Re: Response to January 19, 2012 DRC/URS Comments on Nitrate Corrective Action Plan – Docket No. UGW09-03

Please find enclosed Denison Mines (USA) Corp.'s ("Denison's") revisions, dated February 27, 2012, to the *Nitrate Corrective Action Plan for the White Mesa Mill Site* (the "Plan").

This revision has been prepared in response to comments from the Utah Division of Radiation Control and URS Corporation dated January 19, 2012. The revision has been provided in both clean and track changes ("redline") format for ease of review.

**WHITE MESA MILL SITE PLAN
SHOWING LOCATIONS OF SEEPS AND SPRINGS**

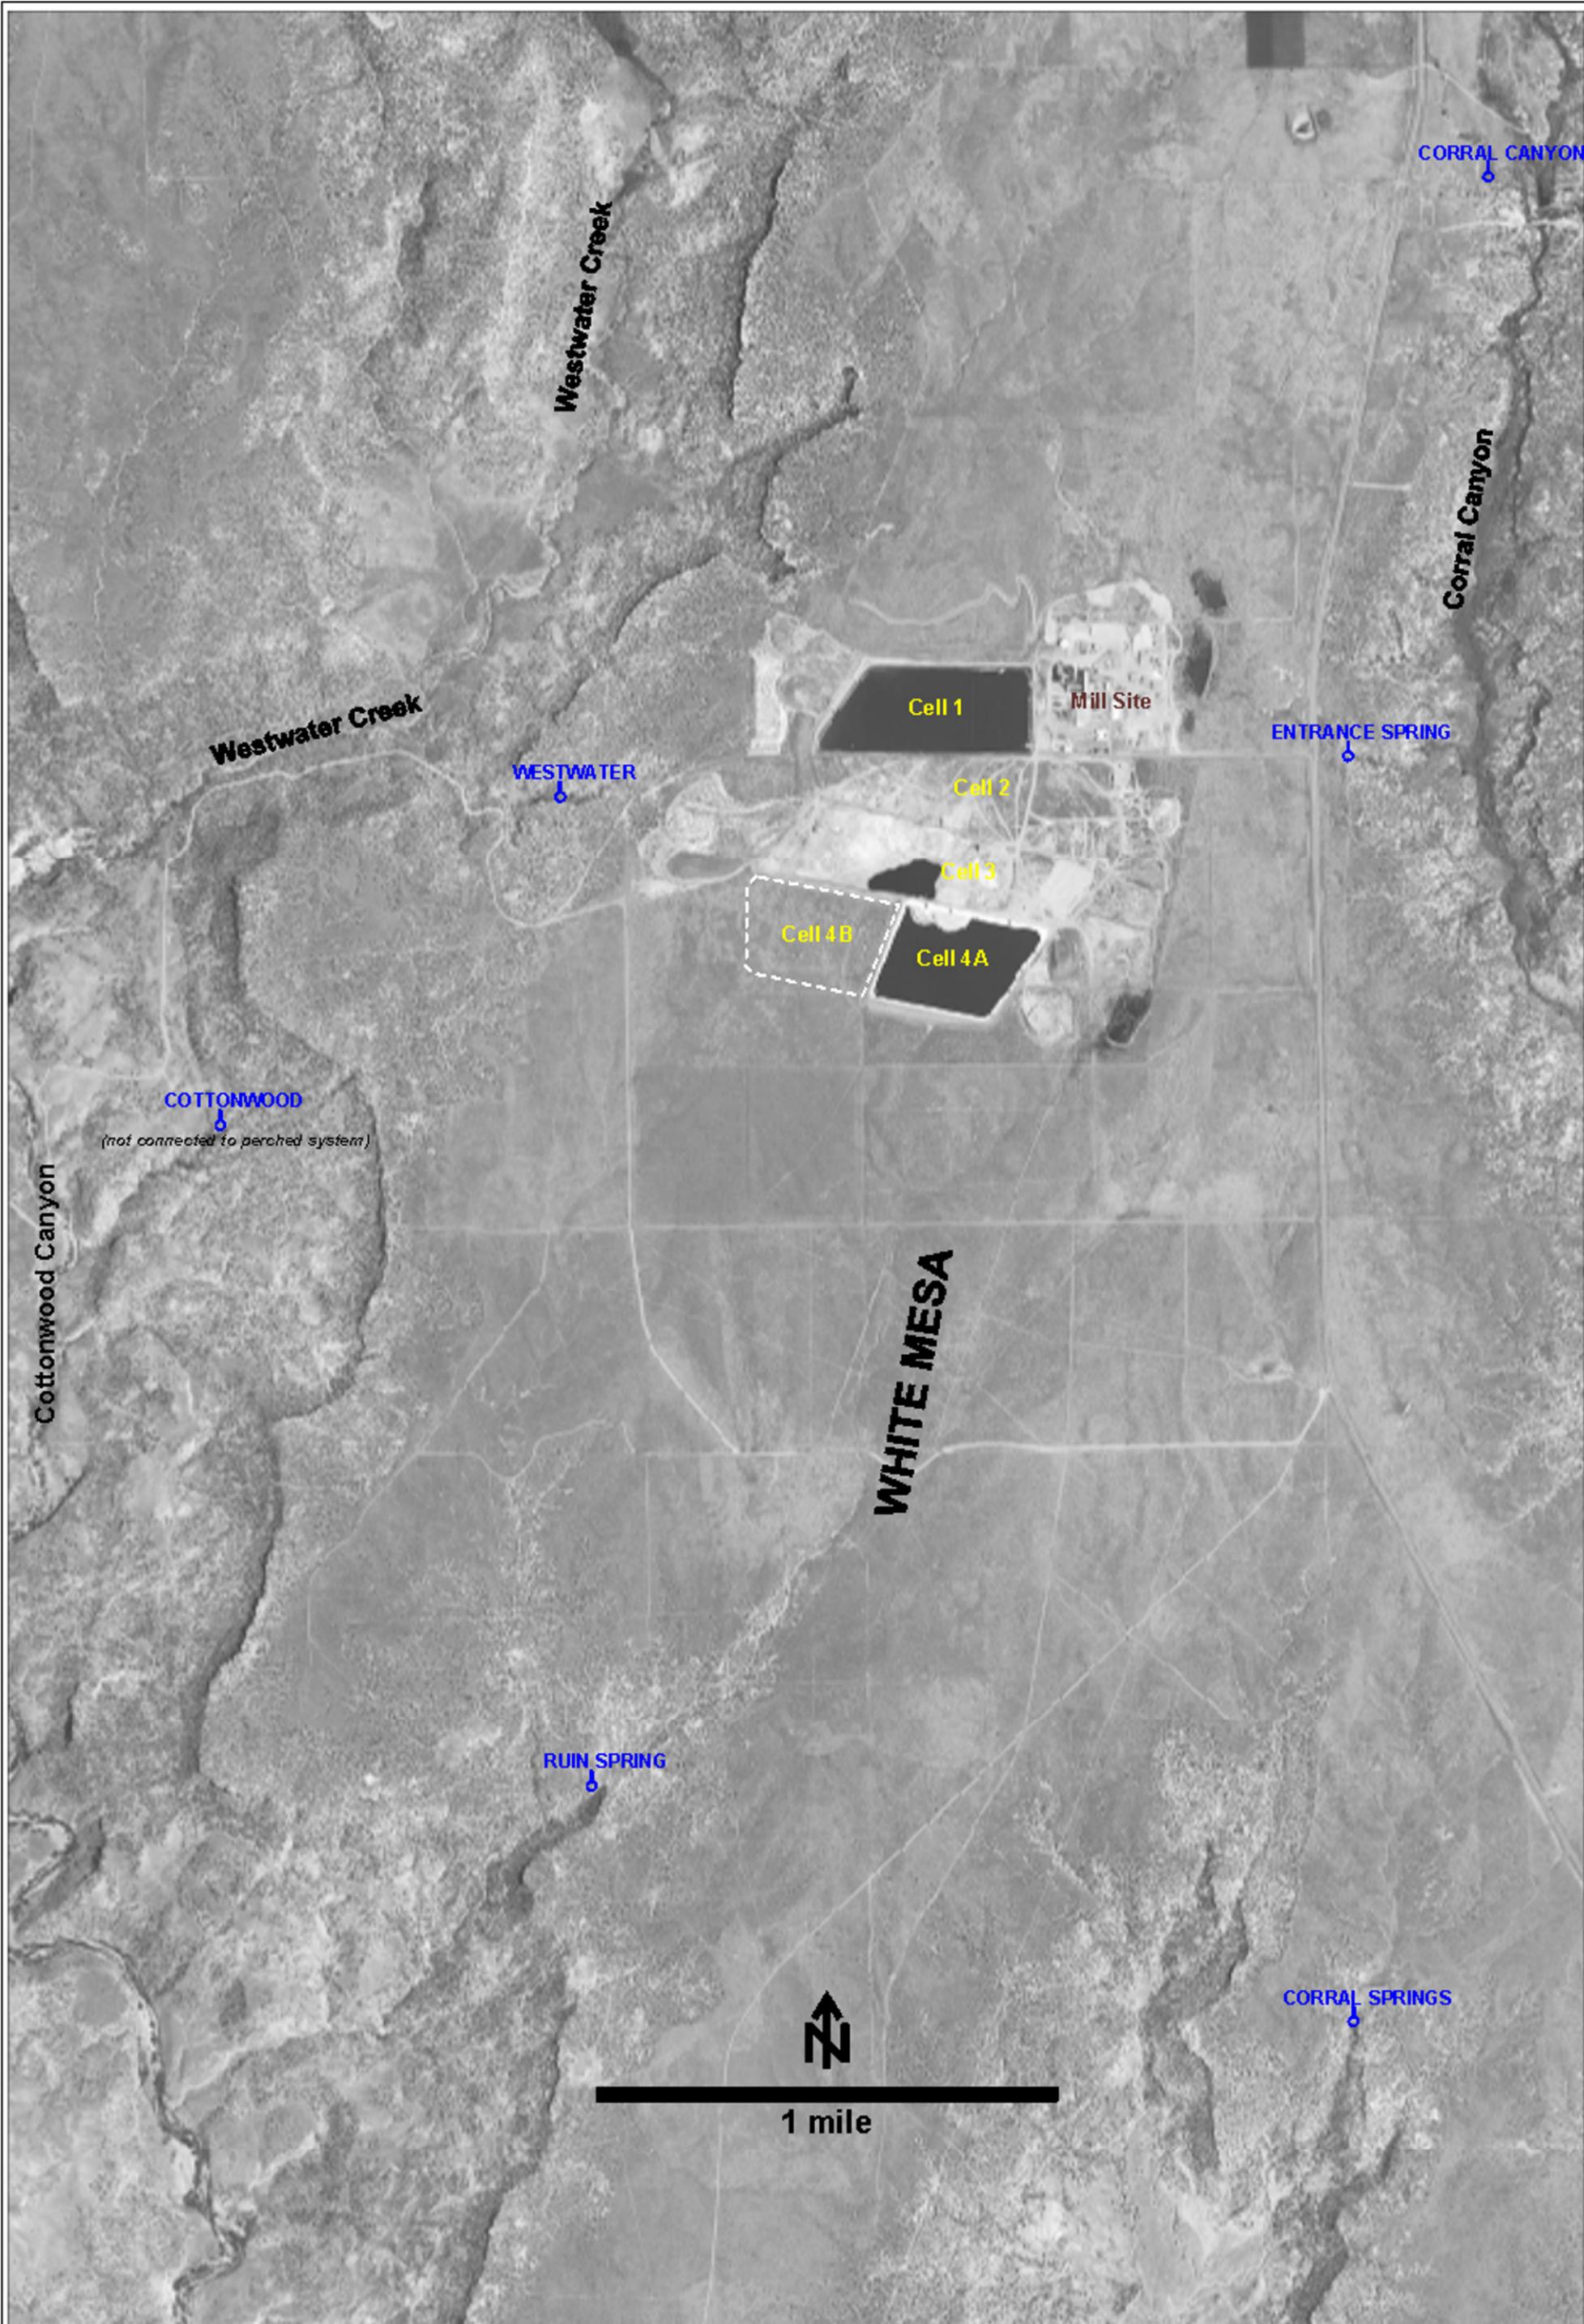
4. A new large-scale Figure 1-1 has been added that shows the indicated features. Existing Figure 1 is now Figure 1-2.
5. The historical pond is the irregularly shaped red figure in the area of TWN-2, and has been labeled on Figure 8 as requested.

KRIGED 3rd QUARTER, 2011 NITRATE (mg/L) (NITRATE + NITRITE AS N) WHITE MESA SITE	
APPROVED SJS	DATE
REFERENCE nov11/nitrate/nit0911v2.srf	H:718000/ nov11/nitrate/nit0911v2.srf
FIGURE 7

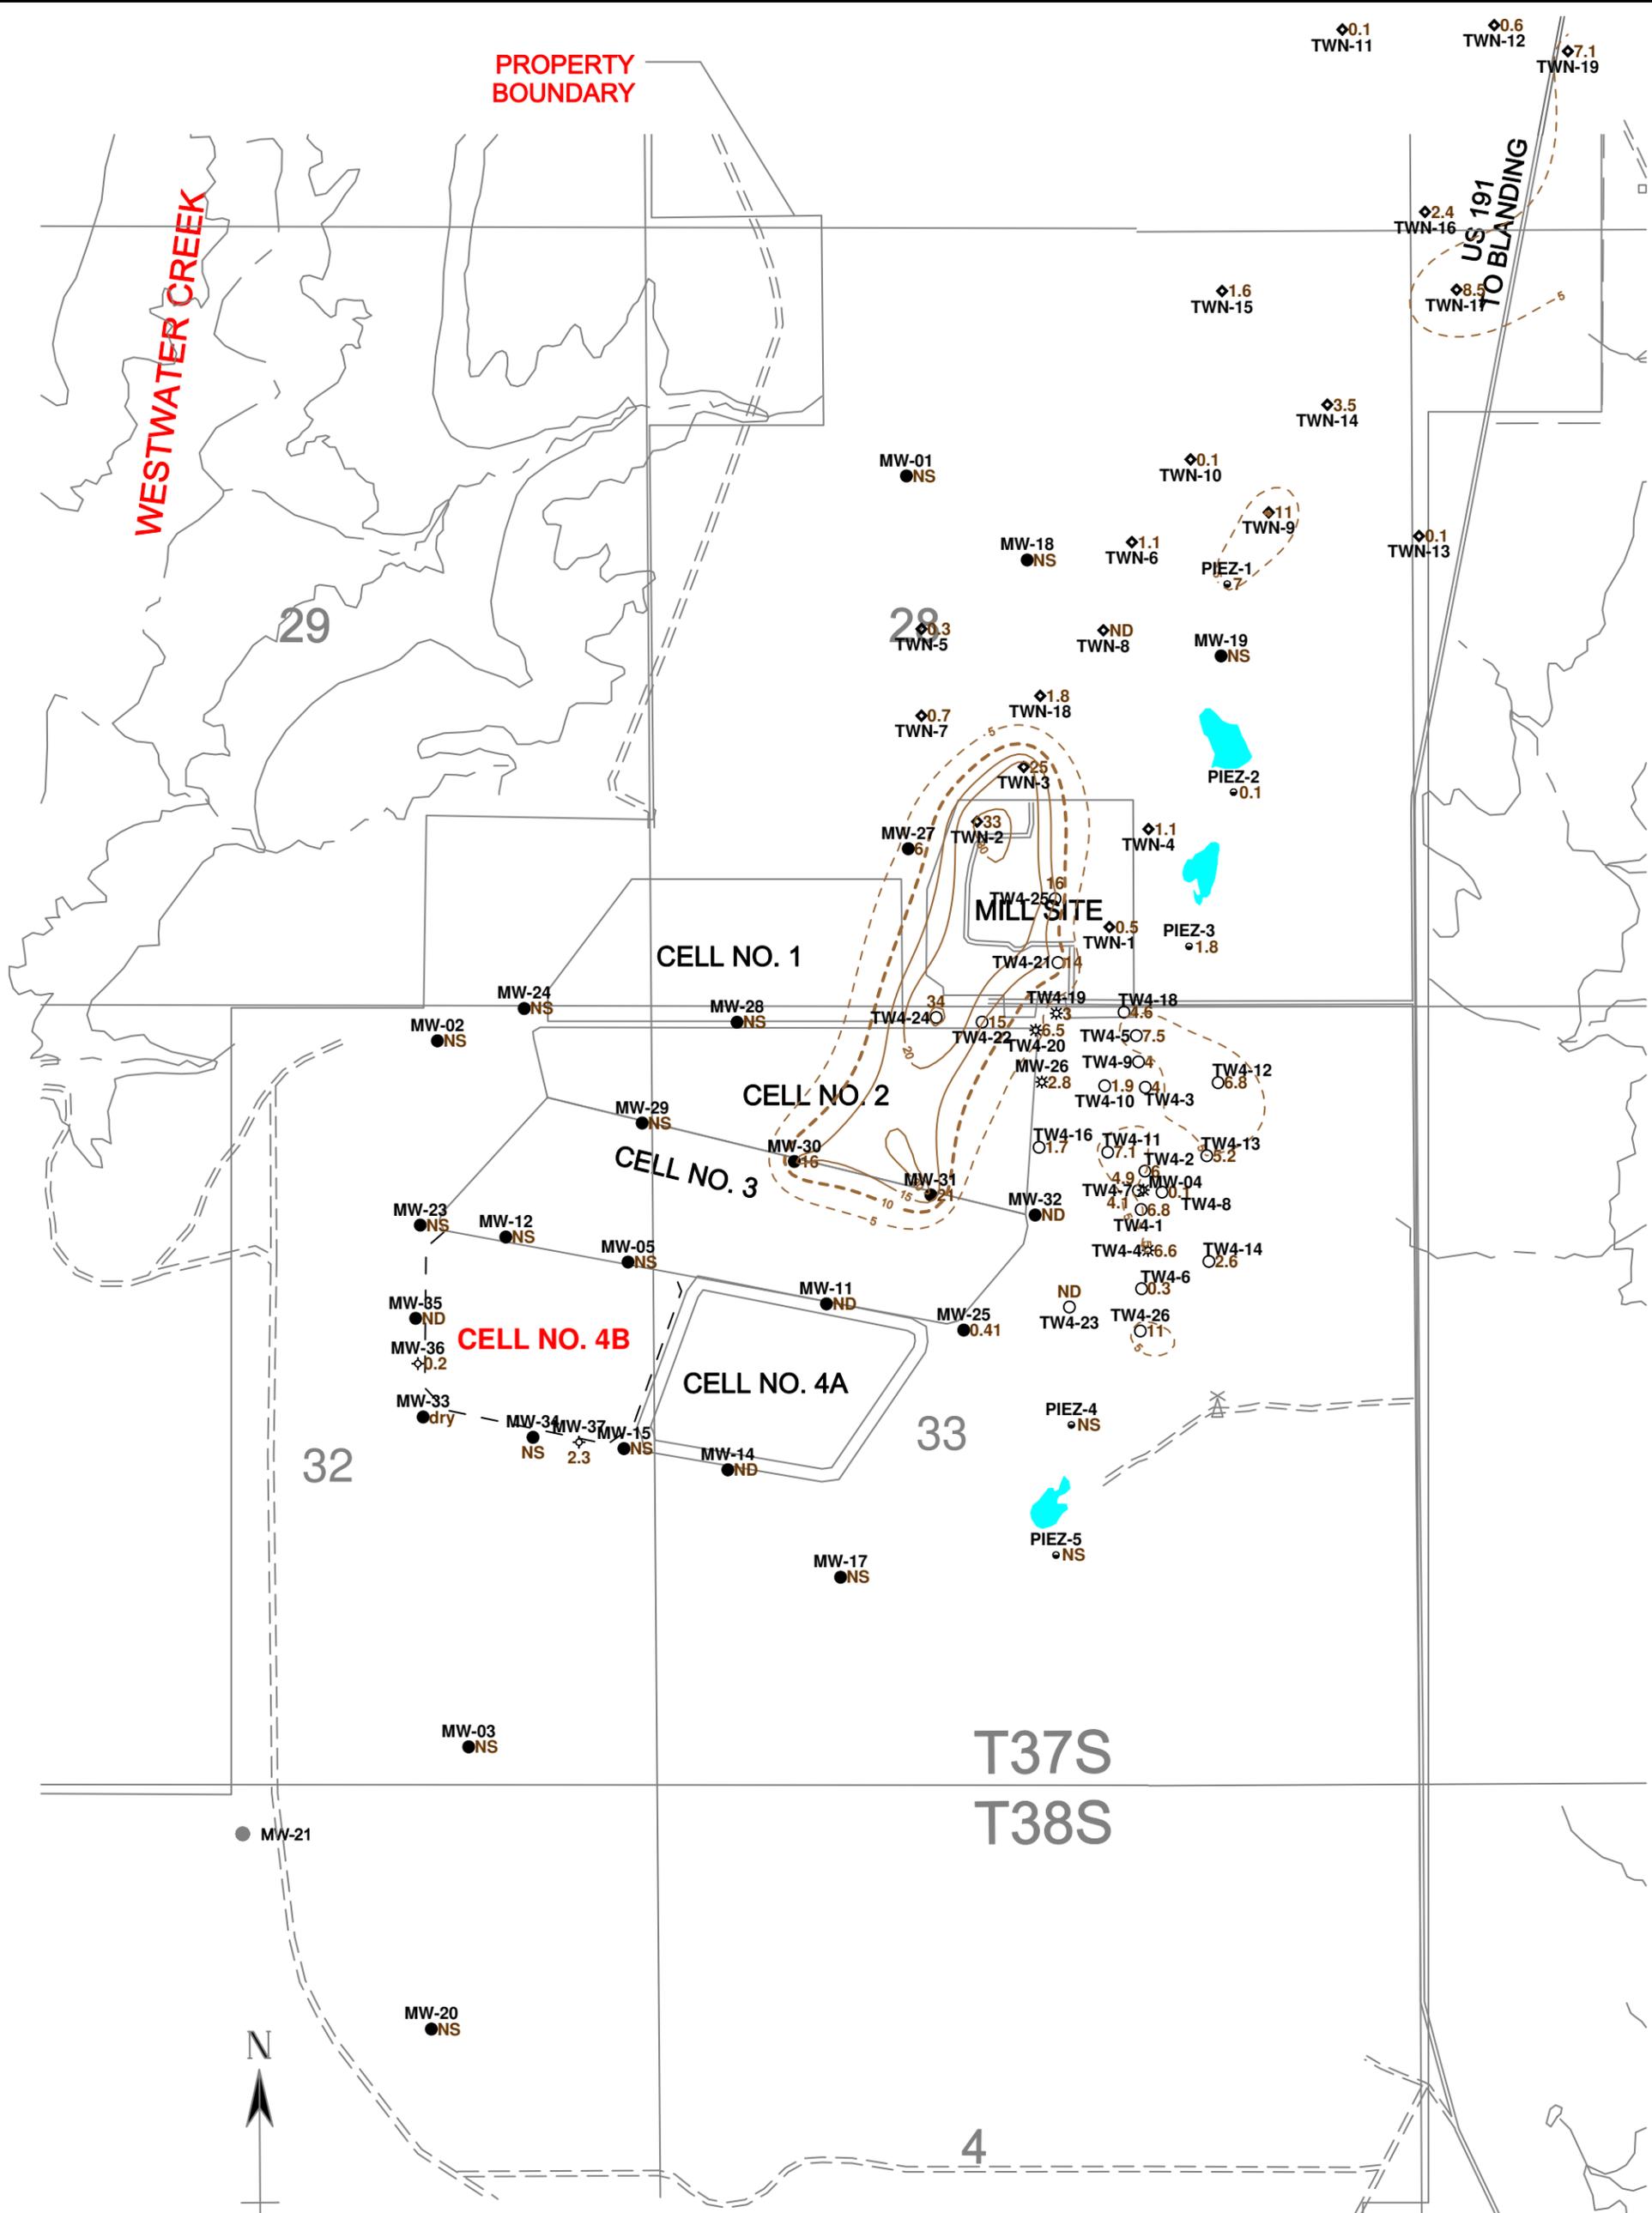
33. The deletion and change to Section 8.6 have been made as requested.
34. The 10 mg/L contour line in each of Figures 7 and 13 has been changed from solid to dashed as requested.
35. The results in Figure 11-1 have been reported as mg/kg on a dry weight basis as requested.

Figure 11-1
Ammonium Sulfate Contamination

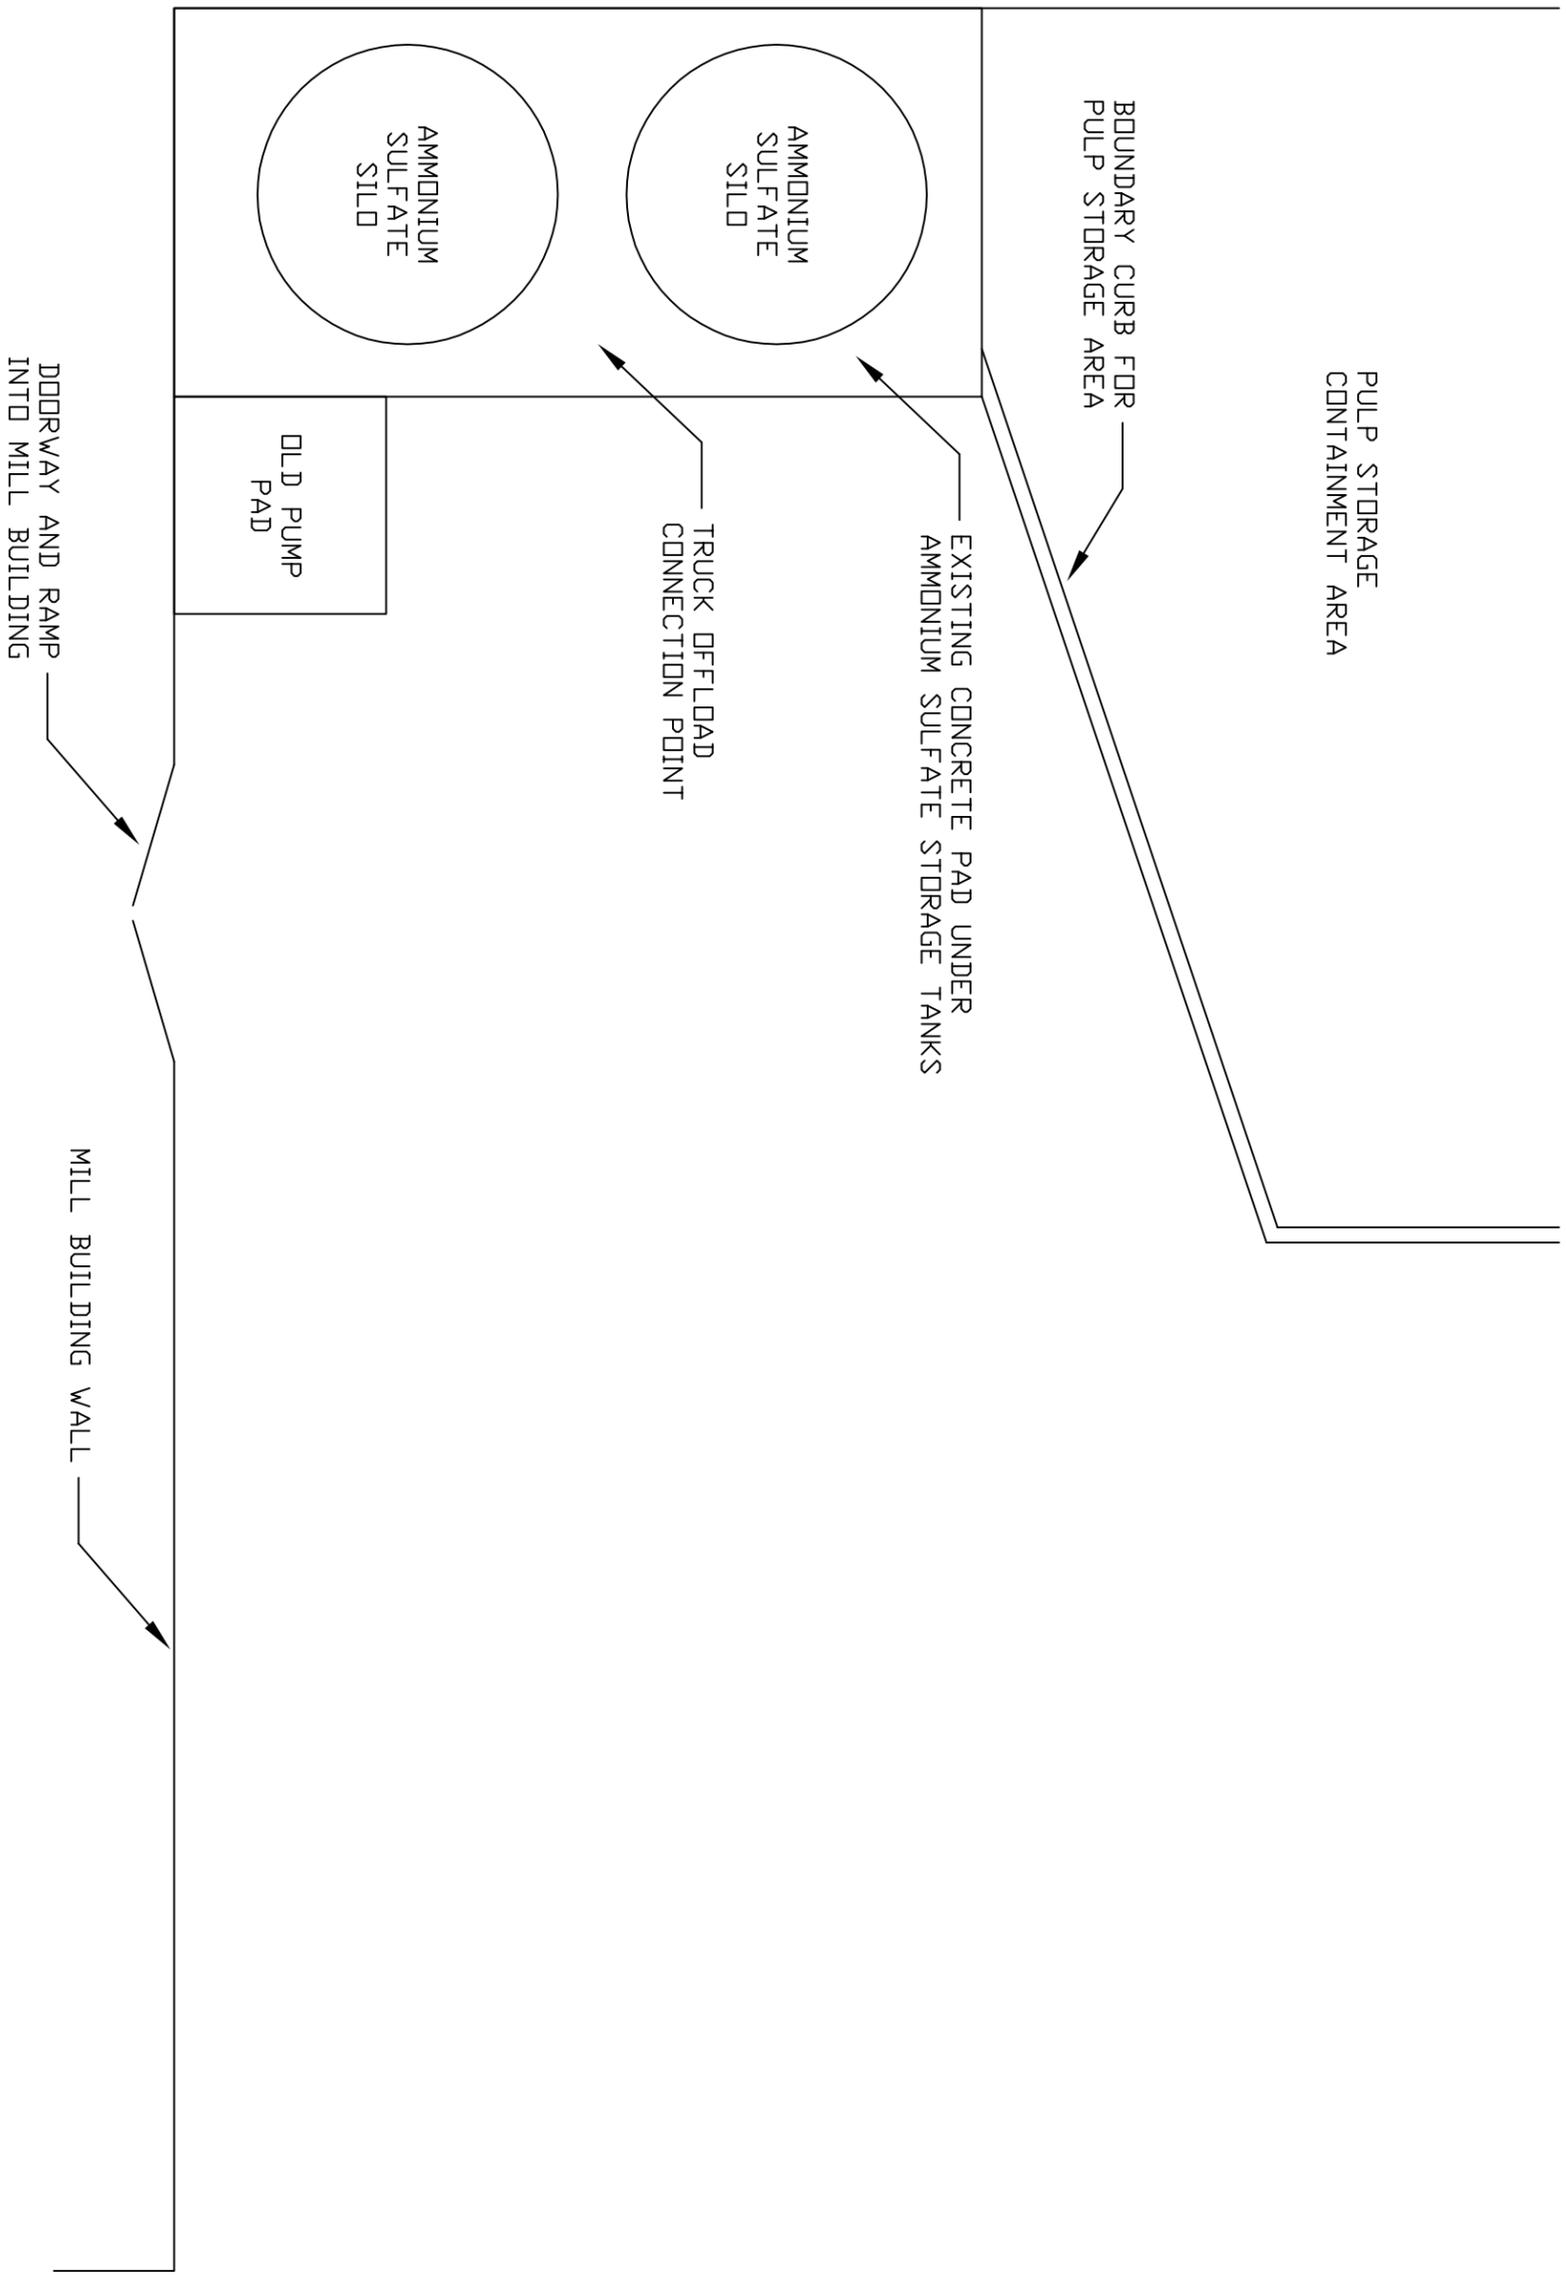
16. The labels have been added to Figure 11-1 as requested.
17. The change has been made to Section 6 as requested.
18. The subject sentence in Section 7 contained a typographic error, and mistakenly referred to Phase III. The sentence has been corrected to refer to Phase II.
